**PROJECT SPECIFIC PLAN FOR EXCAVATION CONTROL  
OF AREAS 3B, 4B, AND 5  
(SUPPLEMENT TO 20300-PSP-0011)**

**FERNALD CLOSURE PROJECT  
FERNALD, OHIO**

**20810-PSP-0006  
REVISION 1  
FINAL**

As noted in the above paragraph, excavation in Area 3B and Area 4B has commenced. All variances documenting the work in these areas, issued under the Project Specific Plan for Area 3A/4A Excavation Characterization and Precertification, 20200-PSP-0009, are attached as Appendix A.

FIGURE 1. LOCATION OF WAC VERIFICATION SAMPLING AREA

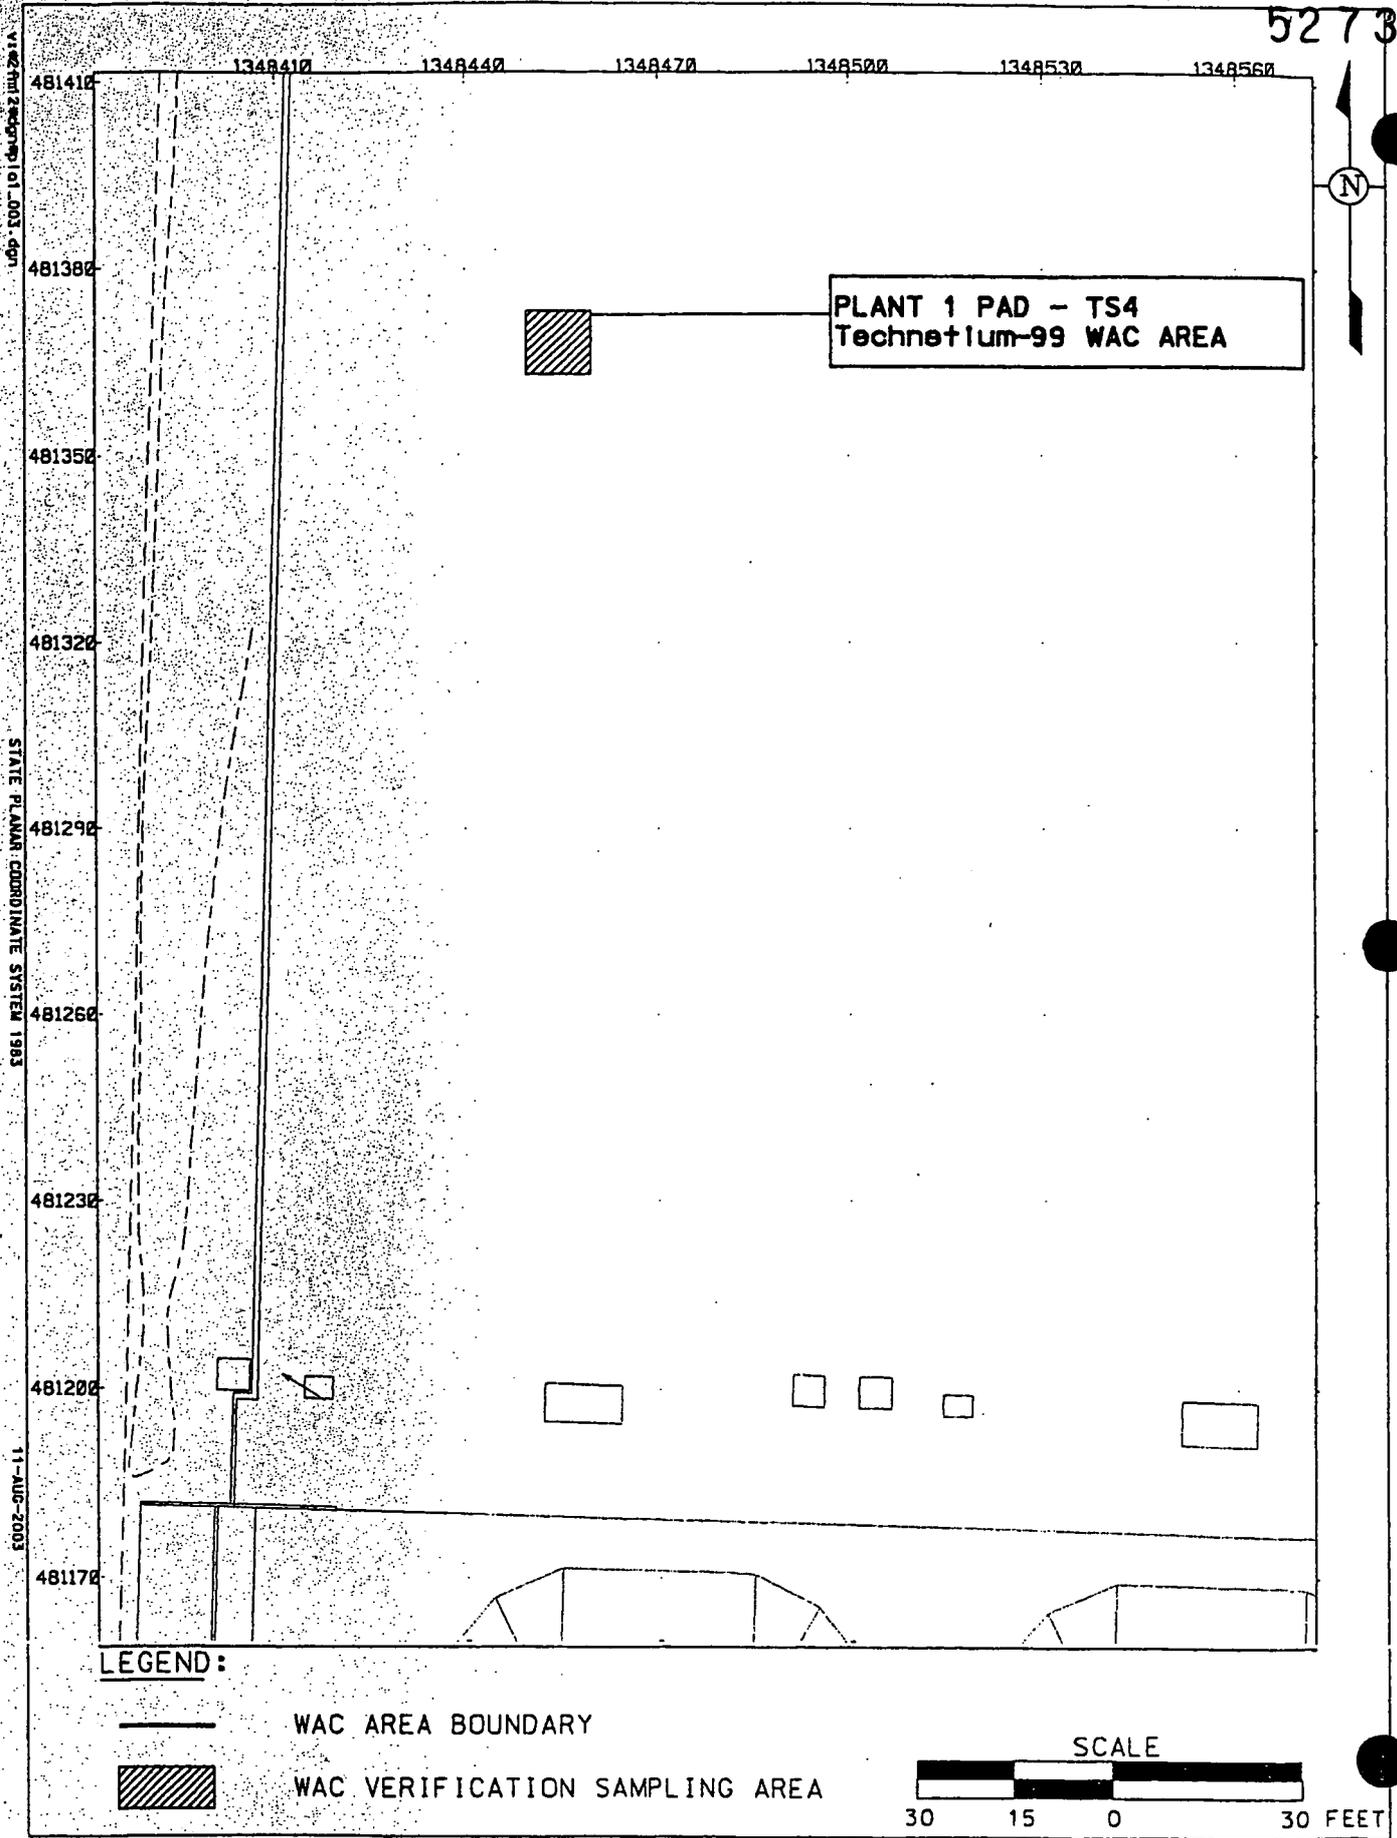
This Variance/Field Change Notice (V/FCN) documents the collection of grab soil samples in Area 3B from Plant 1 Pad -TS4 area for technetium-99. This particular AWAC area is not in the 3A/4A scope. A formal PSP to describe the remainder of Area 3B is in process and will be submitted in the near future. Samples are to be collected in the above-WAC Technetium-99 area that has been excavated to design grade to verify above-WAC technetium-99 has been removed, see Figure 1. This area is approximately 10' by 10'. Coordinate with the Construction Lead and/or WAO Representative for this sampling event.

This V/FCN request the collection of soil samples in Area 3B from the Plant 1 Pad-TS4  
AWAC area for Tc-99. Ohio EPA approves this variance.

FIGURE 1. LOCATION OF WAC VERIFICATION SAMPLING AREA

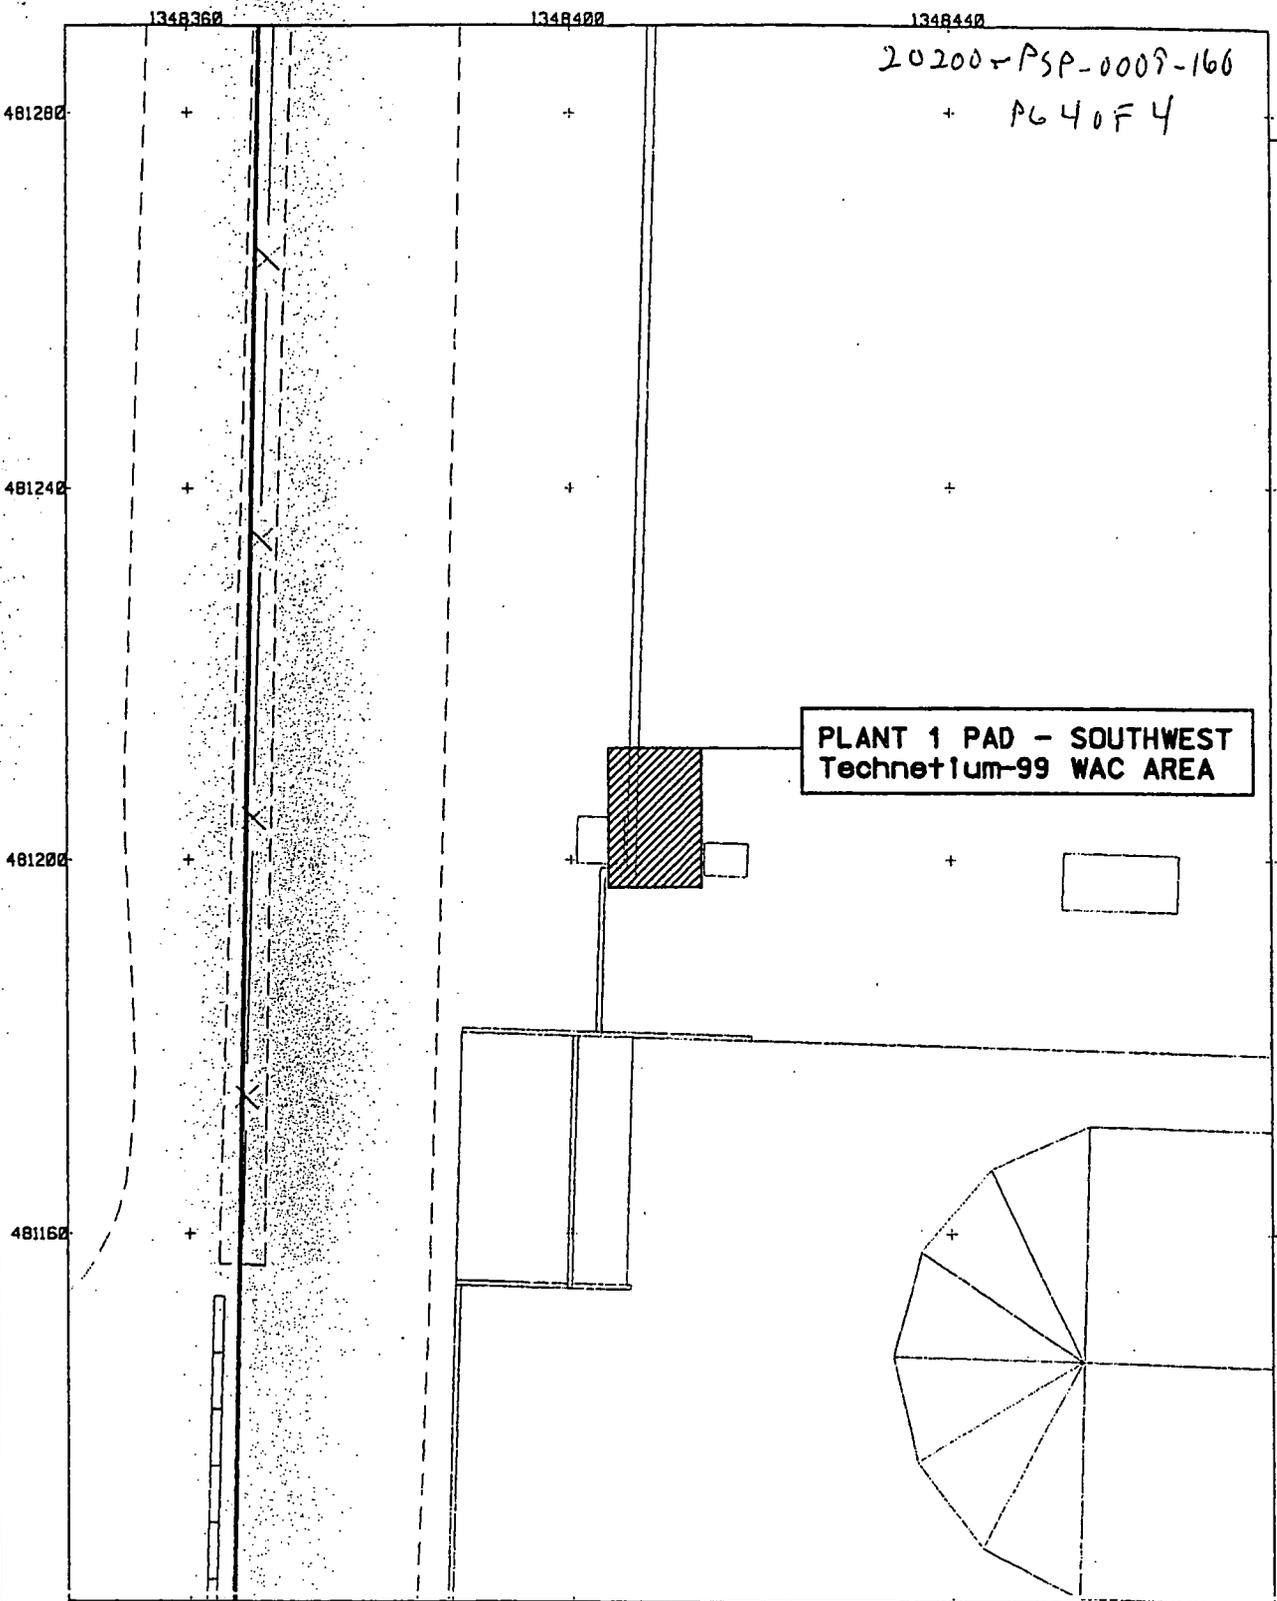
This Variance/Field Change Notice (V/FCN) documents the collection of grab soil samples in Area 3B from Plant 1 Pad -SW area for technetium-99. This particular AWAC area is not in the 3A/4A scope. A formal PSP to describe the remainder of Area 3B is in process and will be submitted in the near future. Samples are to be collected in the above-WAC Technetium-99 area that has been excavated to design grade to verify above-WAC technetium-99 has been removed, see Figure 1. This area is approximately 10' by 21'. Coordinate with the Construction Lead and/or WAO Representative for this sampling event.

This VIFCN request the collection of soil samples in Area 3B from the Plant 1 Pad-Southwest AWAC area for Tc-99. Ohio EPA approves this variance.

FIGURE 1. LOCATION OF WAC VERIFICATION SAMPLING AREA

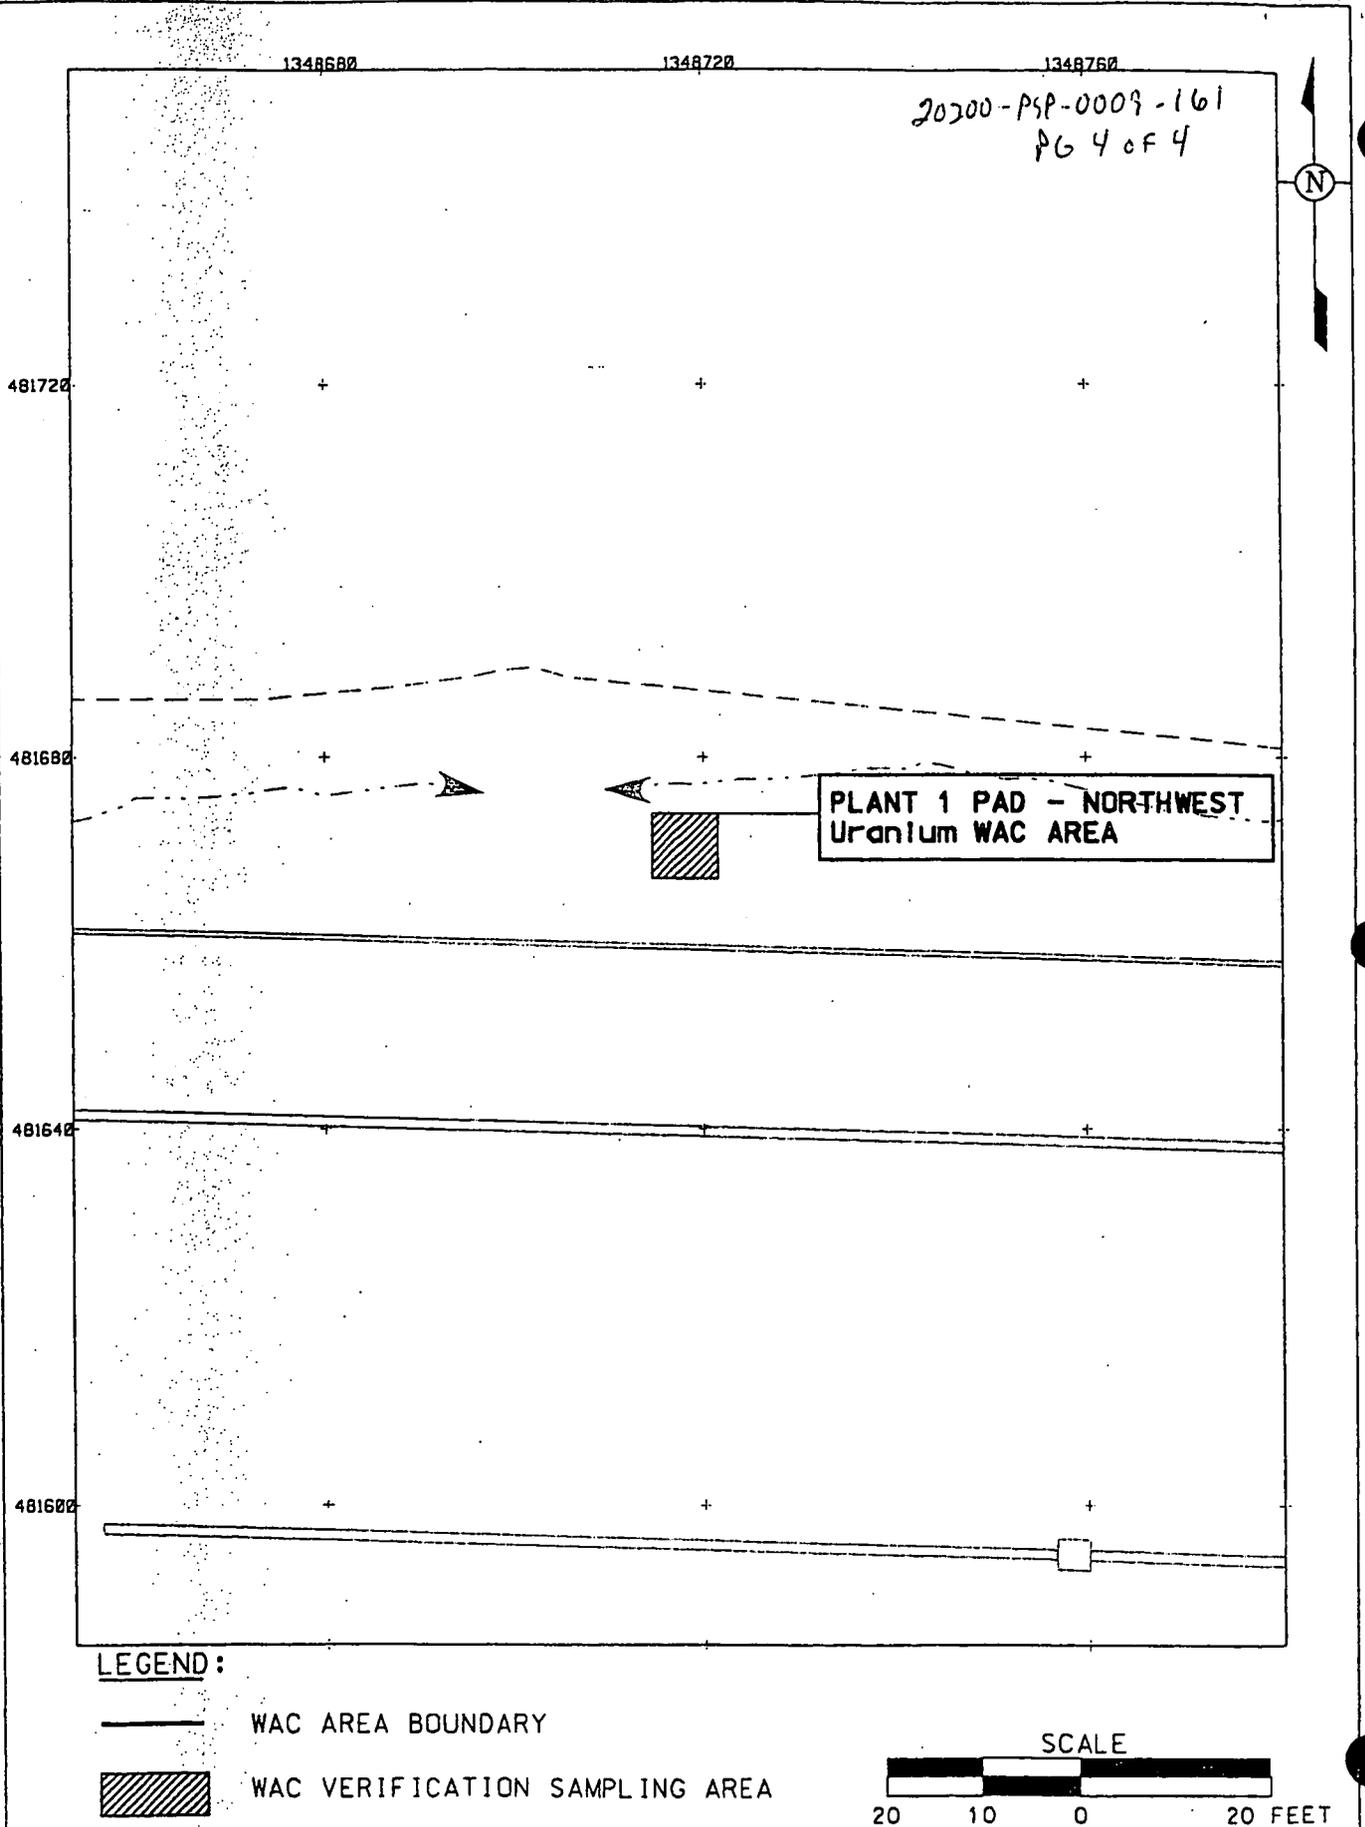
This Variance/Field Change Notice (V/FCN) documents the collection of grab soil samples in Area 3B to replace the real-time scanning requirements in the Plant 1 Pad - Northwest area for total uranium. This particular above-WAC area is not in the 3A/4A scope. A formal PSP to describe the remainder of Area 3B is in process and will be submitted in the near future. Samples are to be collected in the above-WAC total uranium area that has been excavated to design grade to verify above-WAC total uranium has been removed, see Figure 1. This area is approximately 8' by 8'. Coordinate with the Construction Lead and/or WAO Representative for this sampling event.

This VIFCN request the collection of soil samples in Area 3B from the Plant 1 Pad-Northwest AWAC area for total uranium in lieu of real-time scanning. Ohio EPA approves this variance.

Figure 1  
Area 3A/4A Excavation Characterization and Precertification  
20200-PSP-0009 Variance 164

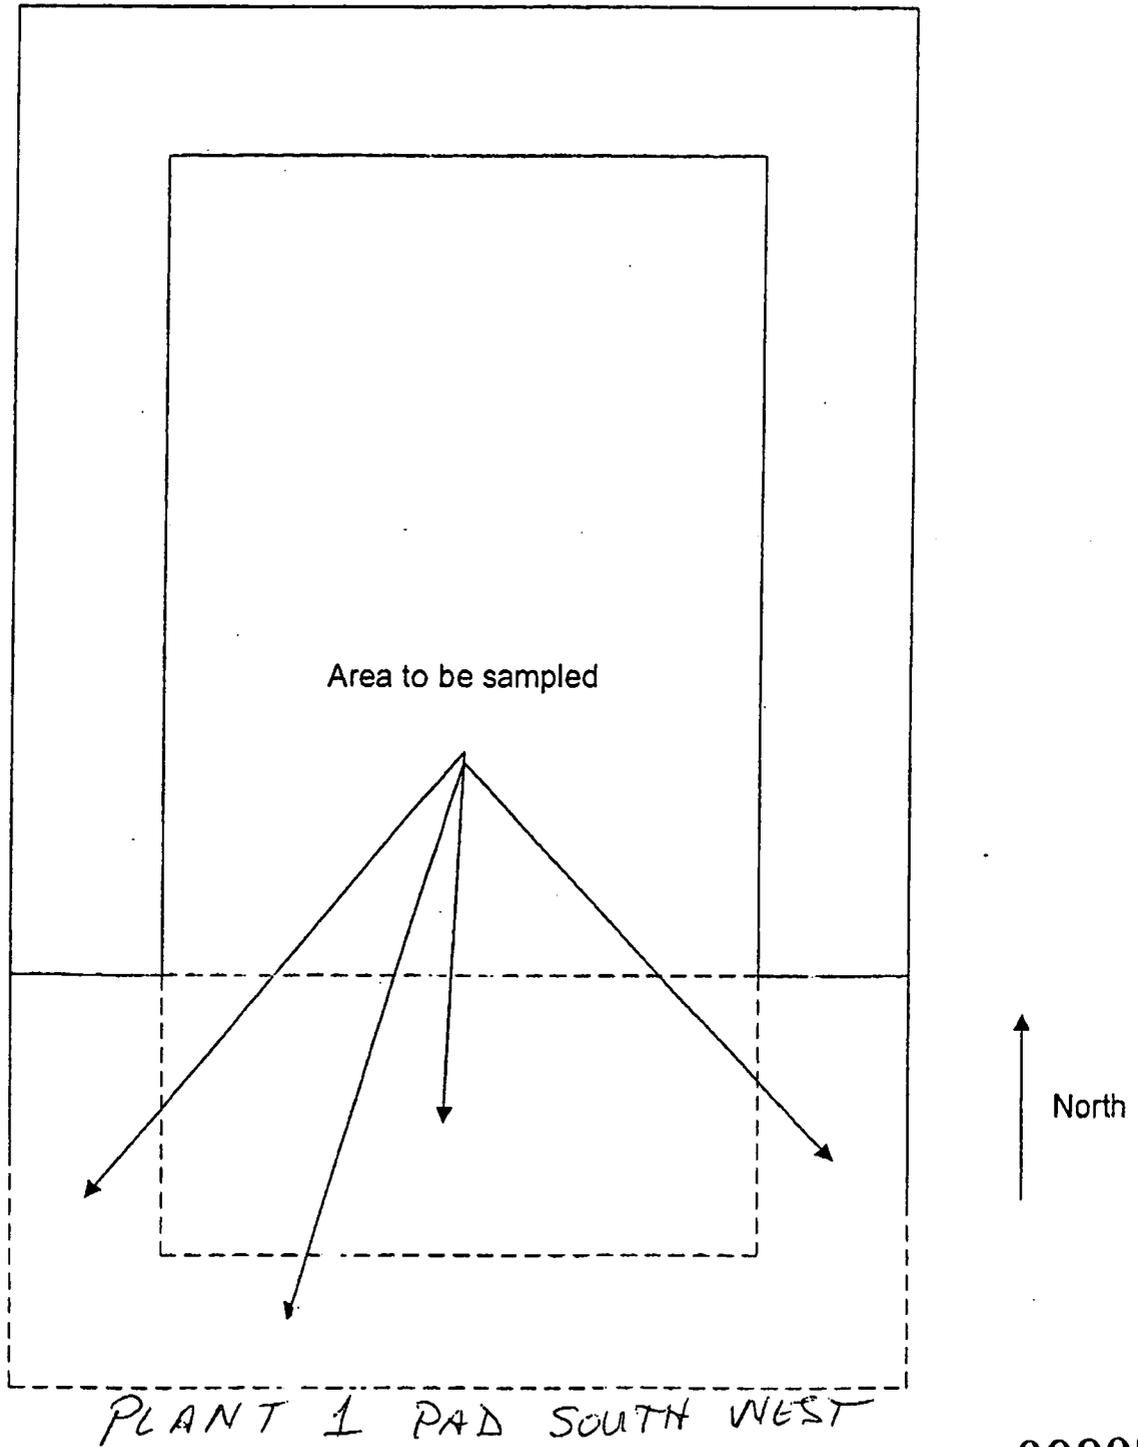
This Variance/Field Change Notice (V/FCN) documents the collection of grab soil samples in Area 3B from Plant 1 Pad -SW area for technetium-99. This particular AWAC area is not in the 3A/4A scope. A formal PSP to describe the remainder of Area 3B is in process and will be submitted in the near future. The designed above-WAC area was extended, and excavated, approximately 4 feet to the south due to above-WAC sample results for technetium-99 (sample numbers 3BE-P1SW-DG-7^TC and 3BE-P1SW-DG-8^TC from variance 20200-PSP-0009-160). Figure 1 provides a general drawing of the approximate area that is to be sampled. Samples are to be collected in the extended above-WAC technetium-99 area that has been excavated to verify above-WAC technetium-99 has been removed, see Figure 1. This extended area is approximately 4' by 10'. Coordinate with the Construction Lead and/or WAO Representative for this sampling event.

This V/FCN requests the collection of grab soil samples in Area 3B from Plant 1 Pad in the SW area for above-WAC Tc-99. Ohio EPA approves this variance.
